MFN 05-153
Supplement 1

**Subject: Response to NRC Request for Additional Information Letter No. 1
Related to ESBWR Design Certification Application – Radiation
Protection – RAI 11.5.3-3 –Supplement 1**

RAI 11.5.3-3 – Supplement 1

Figure 11.5-1. Location of Radiation Monitors

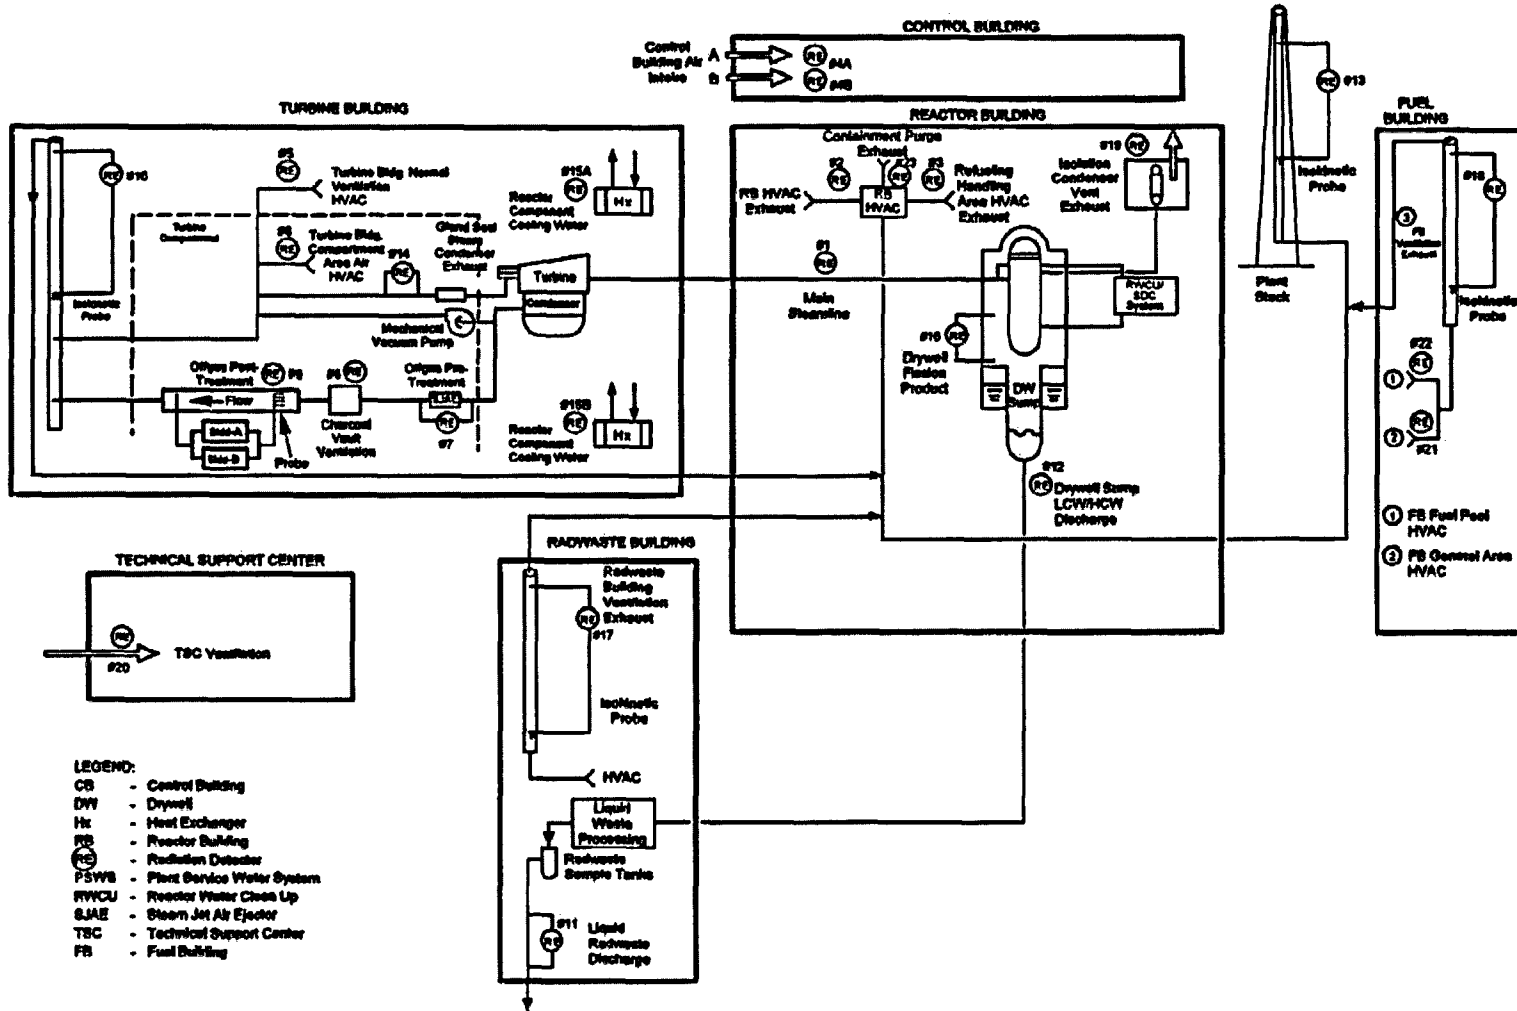
The designation of radiation monitoring systems and their respective ID codes are inconsistently presented in Table 11.5.3 and Figure 11.5-1. This section refers to Table 11.5-3 and Fig. 11.5-1 for information about the designation and ID codes of radiation monitoring systems. A review of instrumentation ID codes indicates that the numbering system is inconsistent for ID No. 21, 22 and 23. The system identified as No. 21 on Fig. 11.5-1 is not listed in Table 11.5-3 and its designation (“#21, COPS”) and function are not described in the Section. As a result, ID codes No. 21 and 22 presented in Table 11.5-3 are not consistent with those shown in Fig. 11.5-1. Also, instrument ID code No. 23 is missing in Table 11.5-3, but is included in Fig. 11.5-1. Provide figures and tables (and text as needed) with updated information.

Figure 11.5-1 - Location of Radiation Monitors

- a. Provide an explanation (footnote) as to how and where do discharges from the Isolation Condenser Vent Exhaust system tie into the Reactor Building HVAC system.
- b. Update drawing to show that the Offgas Post-Treatment RMS is equipped with an isokinetic probe - such as shown for the Turbine Building, Fuel Building, Radwaste Building, and Plant Stack.

DCD Chapter 11, Revision 1 corrected Figure 11.5-1 so that COPS is not shown and the numbers are adjusted, so that reference to COPS is eliminated.

The Isolation Condenser / Passive Containment Cooling (IC/PCC) pool is vented to the atmosphere as shown in ESBWR DCD Figure 5.1-3. It is not routed to Reactor Building HVAC. Under normal IC operating conditions, boil-off steam formed in the compartments containing Isolation Condenser heat exchangers are non-radioactive and has a slight positive pressure relative to station ambient. It is exhausted to atmosphere through large-diameter discharge vents after first passing through a large face area passive-type steam dryer. Moisture removed by the dryer from this boil-off steam is ducted back to the IC/PCC pool.

DCD Figure 11.5-1 will be revised to show the isokinetic probe for the Offgas Post-Treatment subsystem as noted in the attached markup.
